SUBJECT: Request for Amendment to Nuclear Regulatory Commission (NRC)
License BML 12-00722-13, Issued to HQ, AMCCOM

1. Request the following changes be made to our application for subject license dated 15 May 84:

FILTER AND ADAPTER
ASSEMBLY

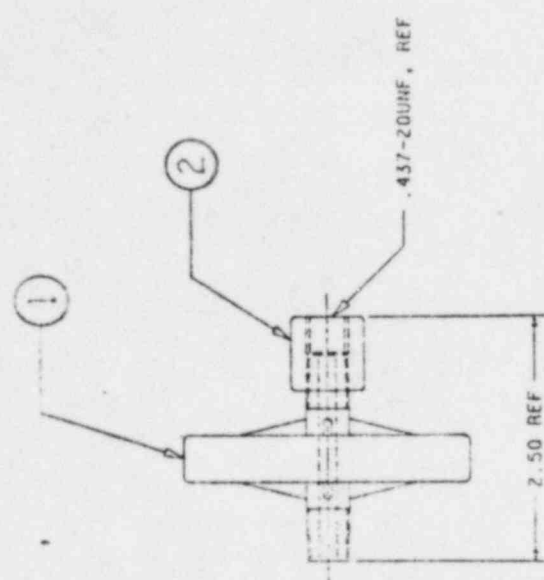
4. The filter system will attach to the exit port of the M43A1 unit. The filter system (drawings attached encl 1-3) employs an 0.2 micron teflon filter in a polypropylene holder which screws into the exit port of the M43A1. Filters with 0.2 micron pore size are used in medical applications to filter out 0.003 to 0.004 micron viruses. This filter was felt suitable, therefore, to adequately filter any particles of the Am-241 which might come from the source. The filter does not impair normal air flow through the M43A1 unit. (Encl 4)
